Technical Note

Project:	Hilfield Solar farm Glare and Glint Study		
Subject:	Review of applicants Glare and Glint Study		
Author:	David Mooney		
Date:	28/05/2021	Project No.:	5193383
Distribution:	Max Saunders	Representing:	Hertsmere Council

Atkins have been commissioned to provide a 3rd party review of the Glare and Glint Study (G&G) produced for Enso Energy by Pager Power covering the proposed Solar Farm Development adjacent to Elstree Aerodrome. The documents under review are: -

Dwelling receptor mitigation requirement flow chart

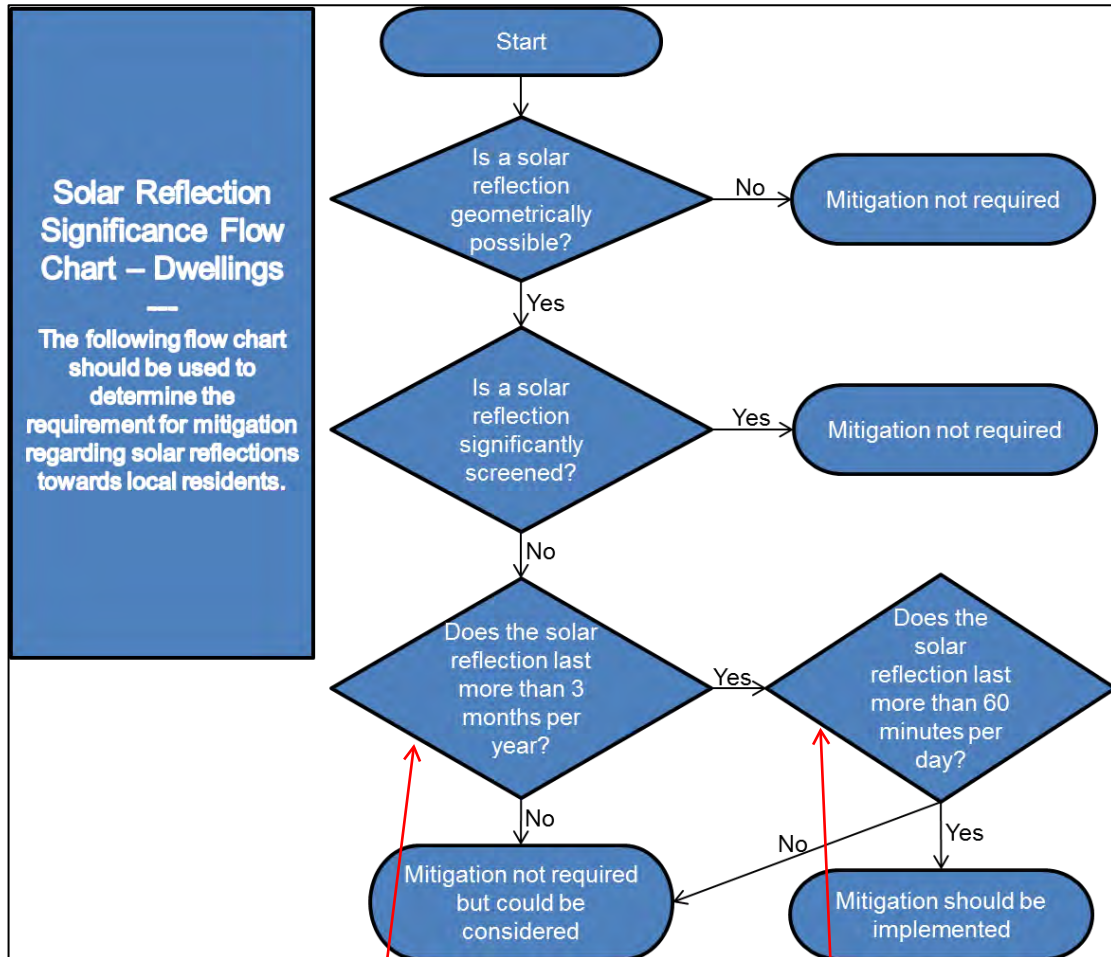
Why 3 months, a week could be significant ?

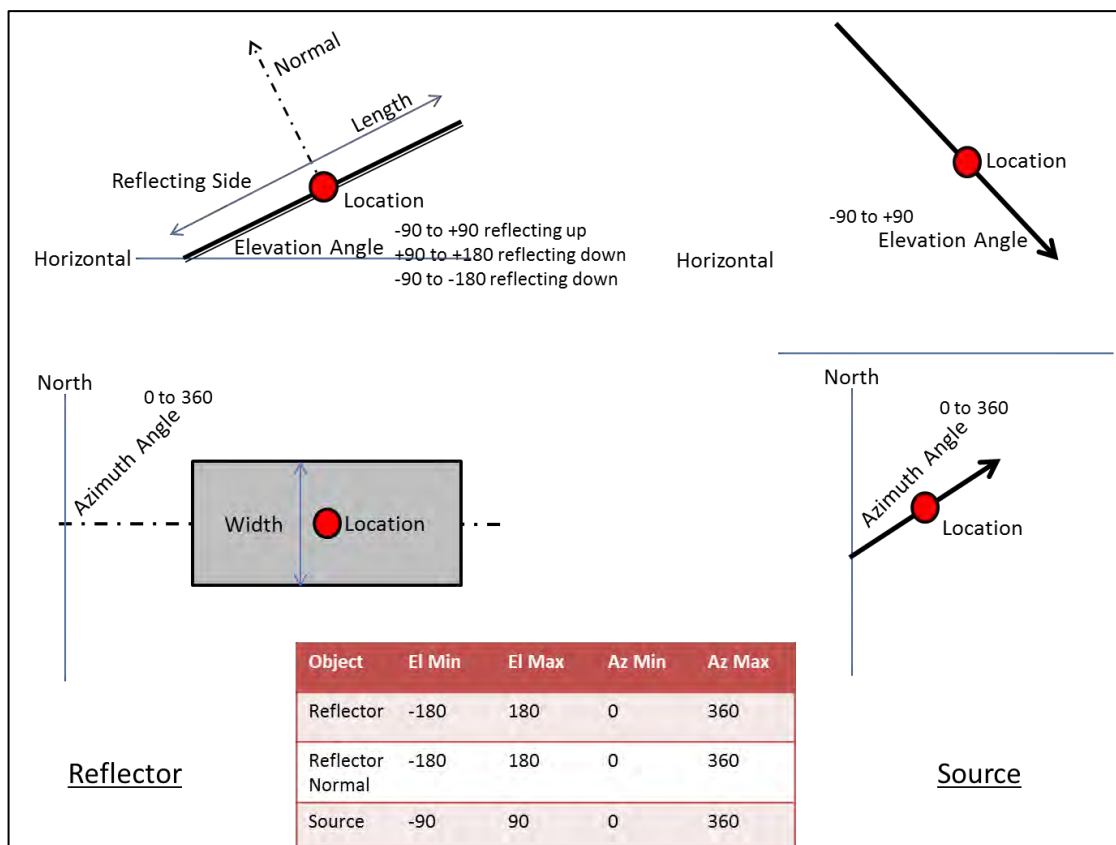
Why 60 mins, it only takes 10 minutes to wake someone with sunlight ?

Observer 1 Results

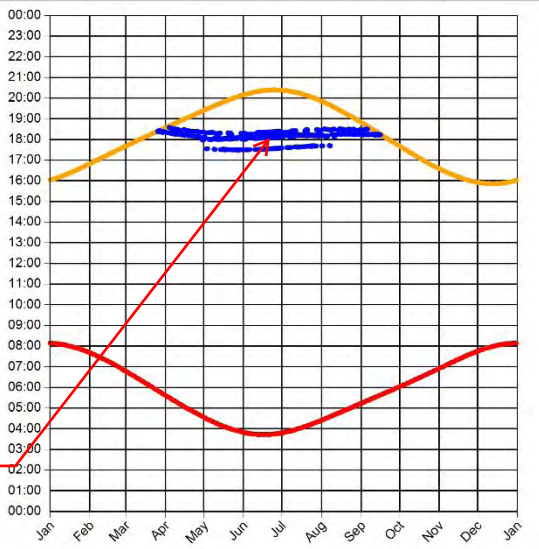
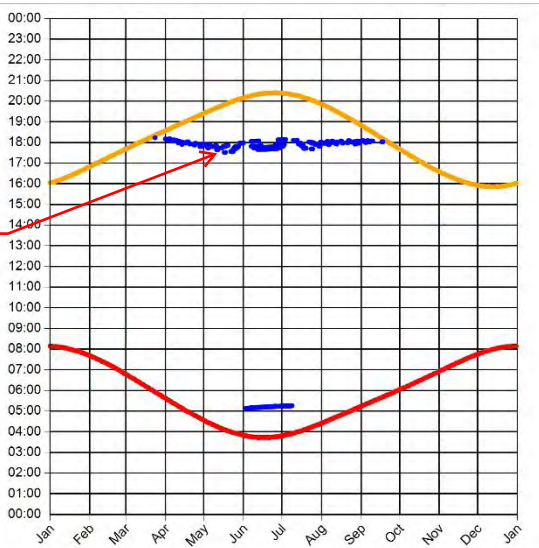
reflections seem almost constant between April and September at 17.30-19:00

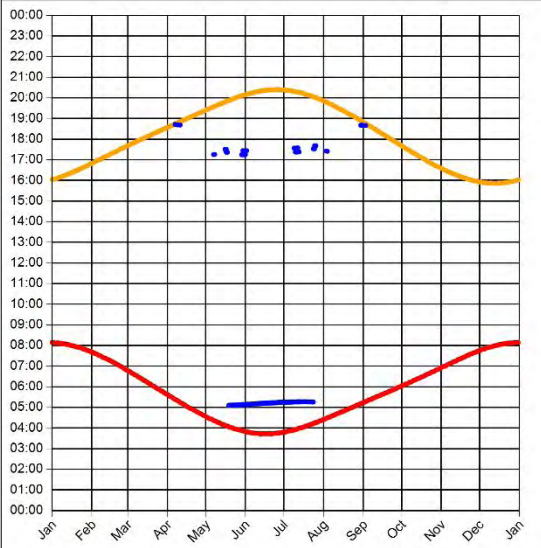
reflections seem almost constant between April and September at 17.00-18:00

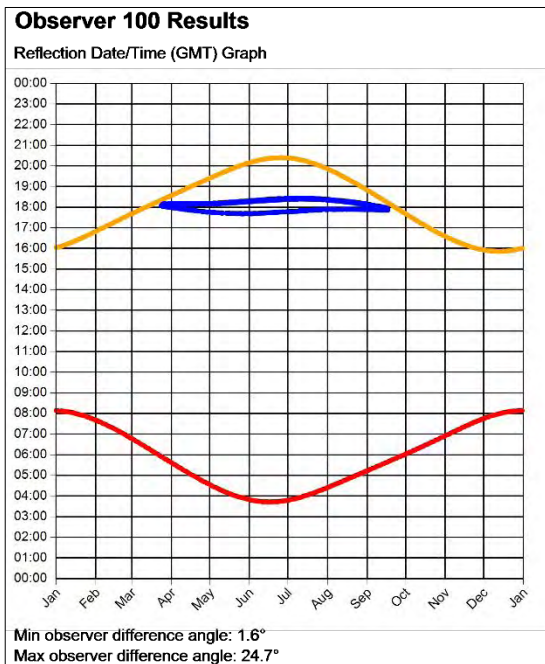
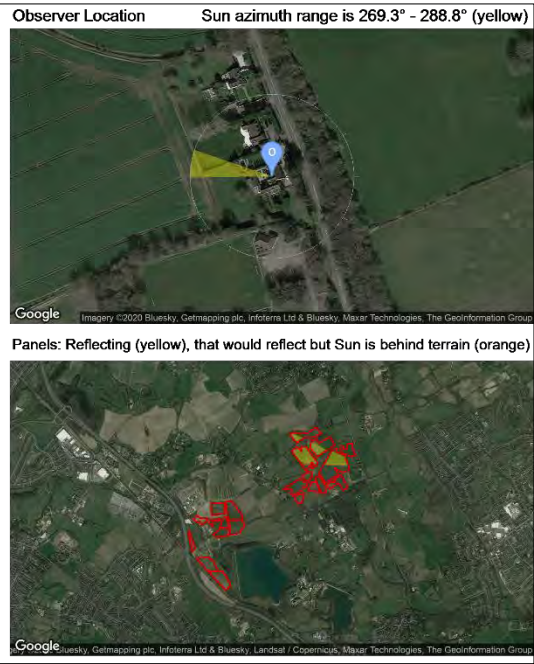
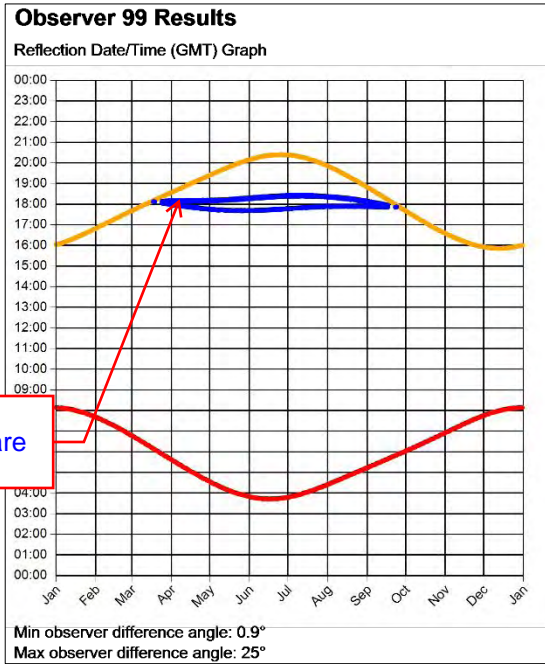
what is the time duration of the glare each day.

APPENDIX I - LEEP PLAN

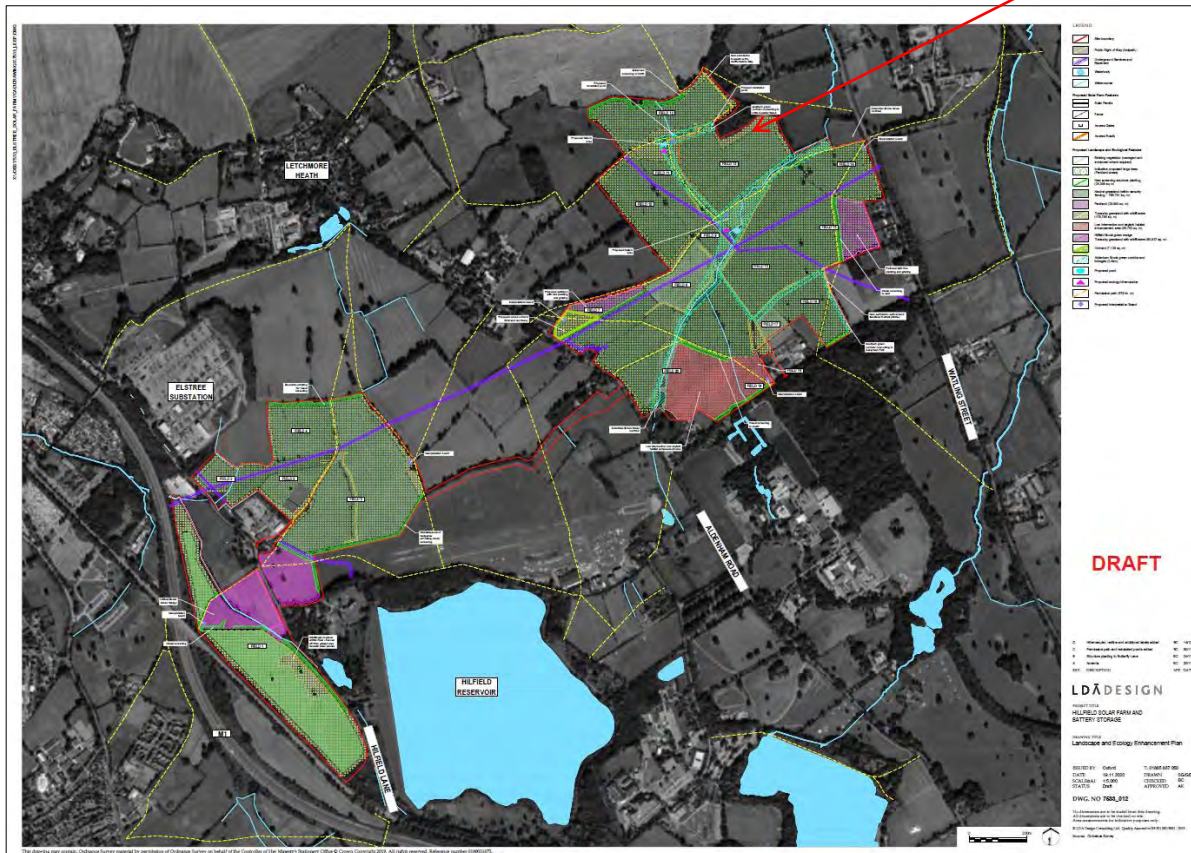
This is unreadable.
